APPEAL SUMMARY

Status: Decision Rendered - Reconsideration of ID 21992

Appeal ID: 22149	Project Address: 2131 SE 12th Ave
Hearing Date: 11/20/19	Appellant Name: Daniel W Keller
Case No.: B-013	Appellant Phone: 2252445900
Appeal Type: Building	Plans Examiner/Inspector: Jason Buerkle
Project Type: residential	Stories: 4 Occupancy: R-3 Construction Type: V-B
Building/Business Name:	Fire Sprinklers: Yes - NFPA 13R Throughout
Appeal Involves: Reconsideration of appeal	LUR or Permit Application No.: 19-170676-RS
Plan Submitted Option: pdf [File 1] [File 2]	Proposed use: Residential Duplex (Non-Townhouse)

Code Section R101.2 Scope/ Four Story Structures Regulated under the Oregon Residential Specialty Code (ORSC 2017); Condition #2

1 Plan, Proposed, 1st Floor
A2.1 Scale: 1/4" = 1'

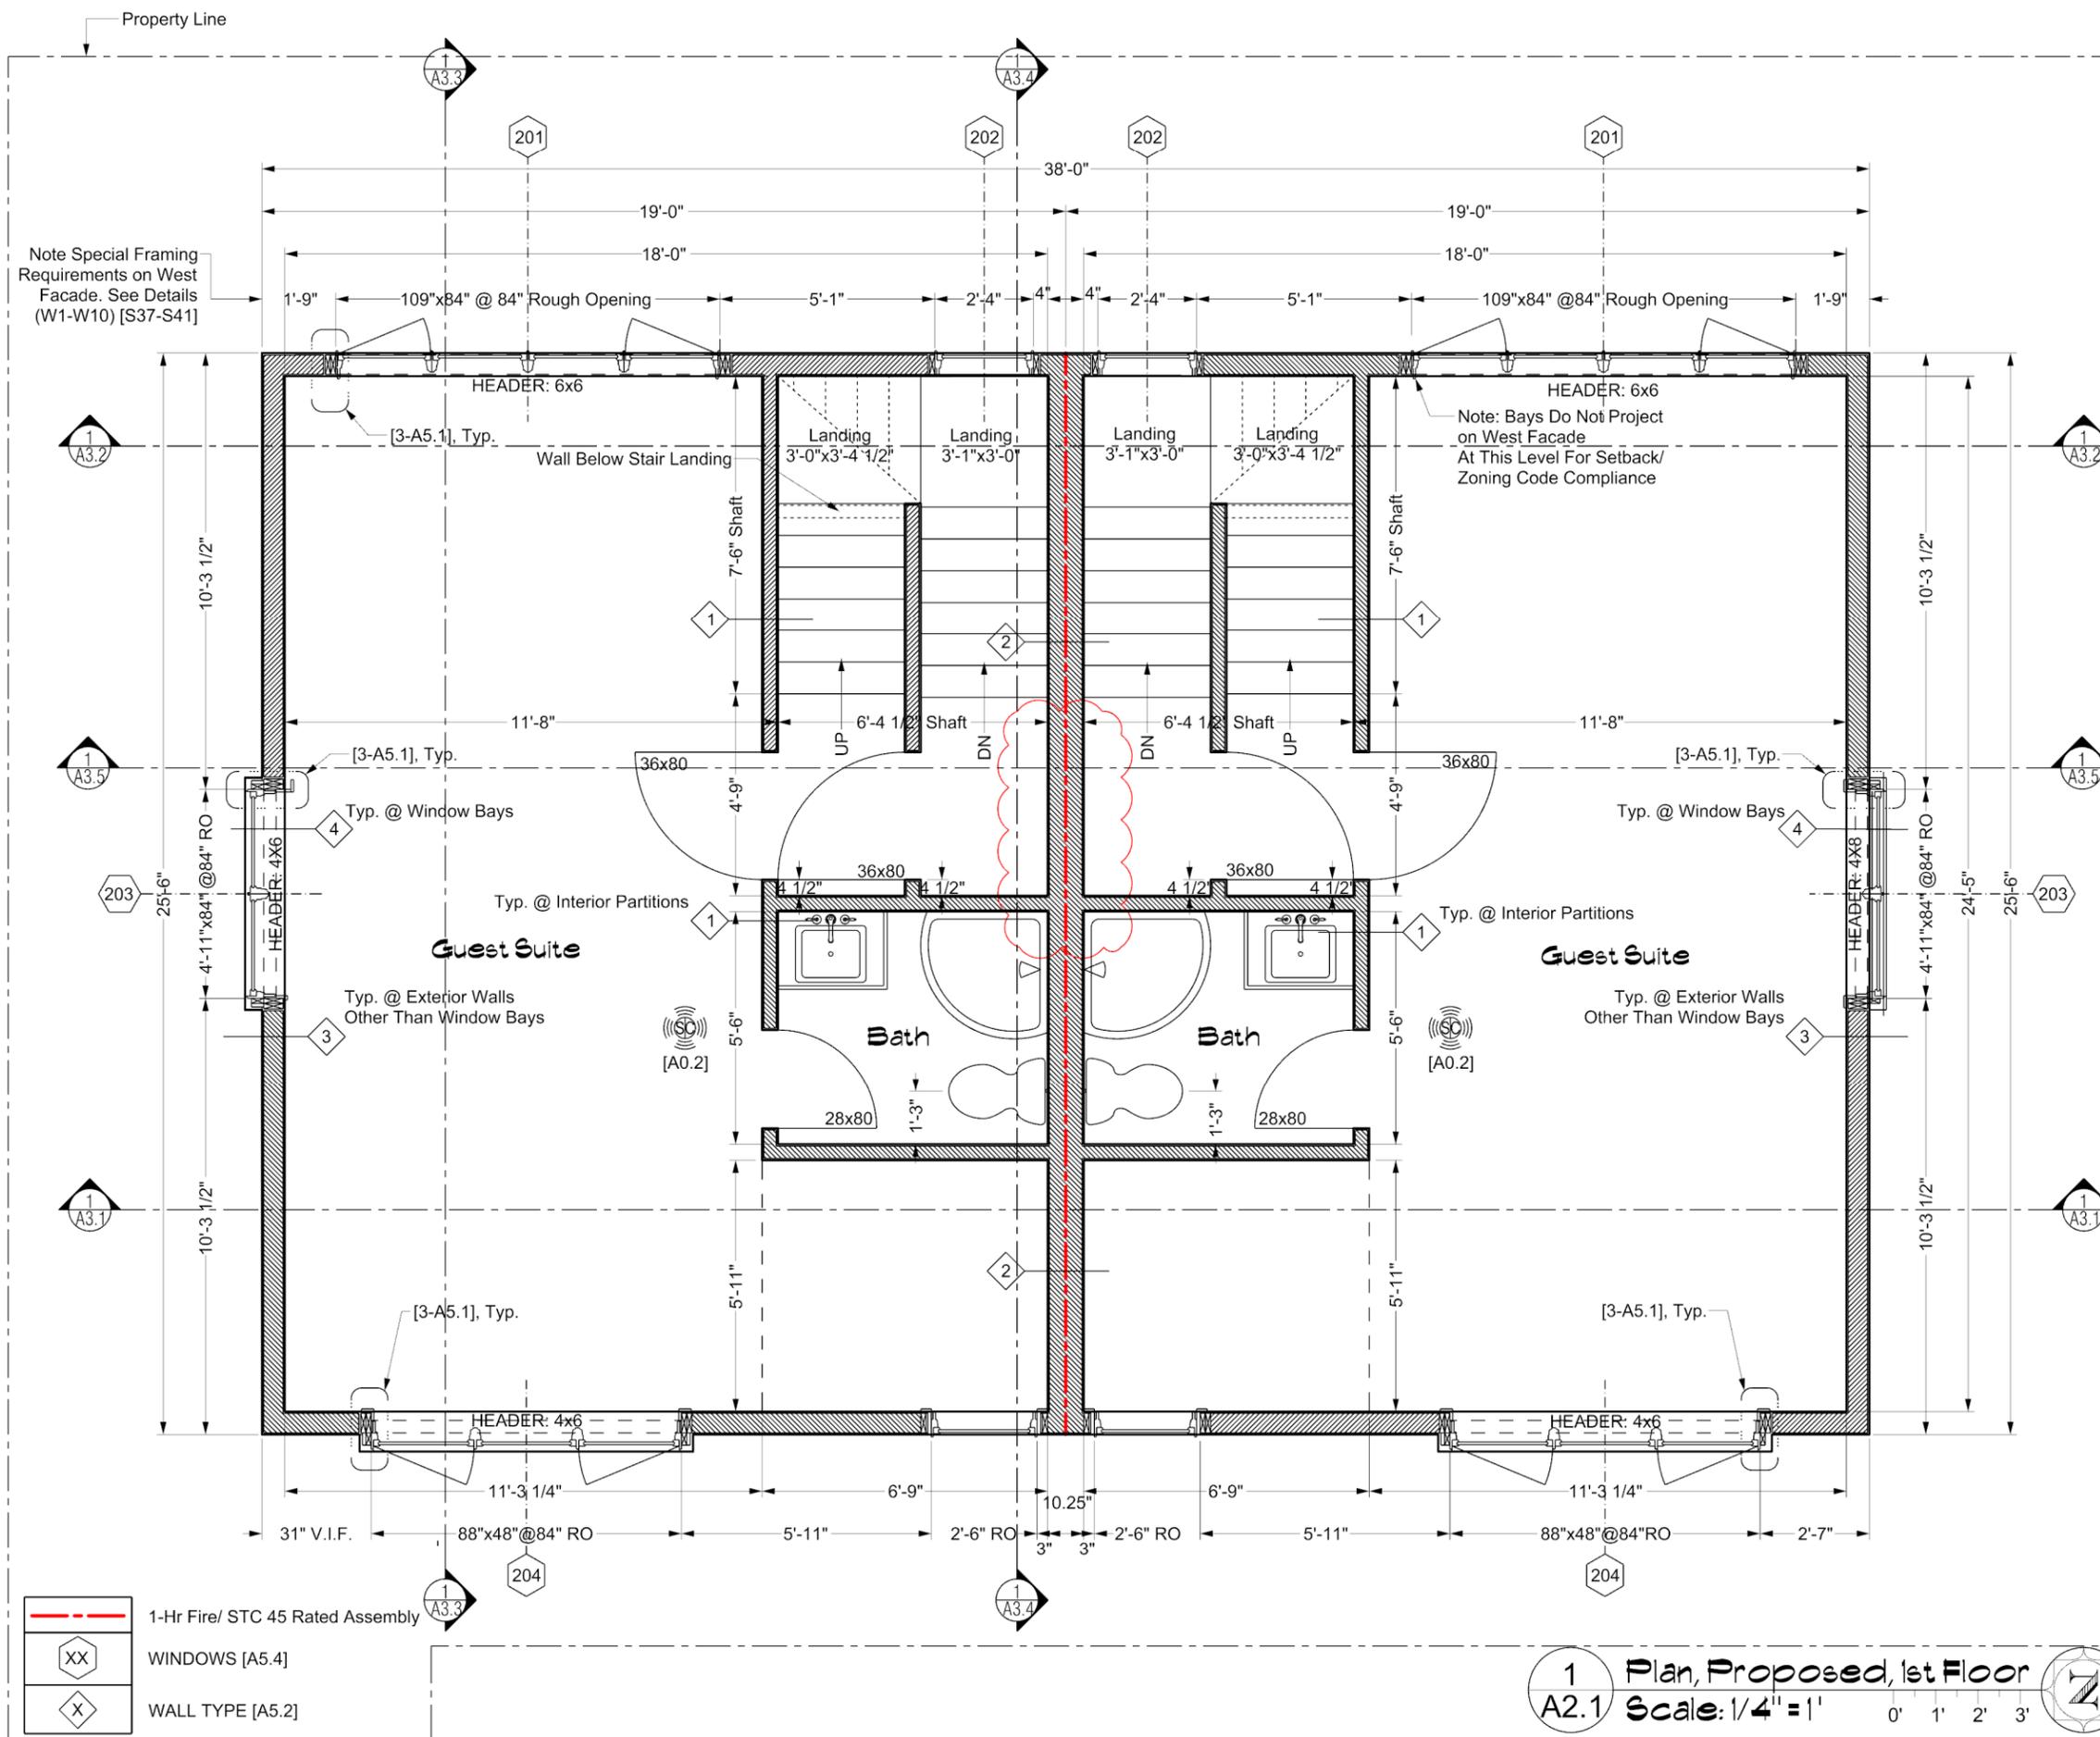
The stair core and ground floor exit hallways [Refer to Plan A2.1] accessed on either side of the communicating door will be classified as "common" space and will be separated from the dwelling units and garages via locking doors and fire-rated partitions & floor/ceiling assemblies [Refer to Plan A2.2 and Section A3.5].

After conversations with John Butler regarding this proposal, the design noted above has been updated to:

Remove the fire-rated emergency egress door as previously proposed connecting the two units. Update the sprinkler system to a NFPA 13R system throughout the building to provide equivalent life safety.

Please see the revised A2.1 plan showing the removed door for reference.

Four story R3 building with one exit on a single level: Granted as proposed.

Note: Separate sprinkler permit is required through Fire Marshal's office.
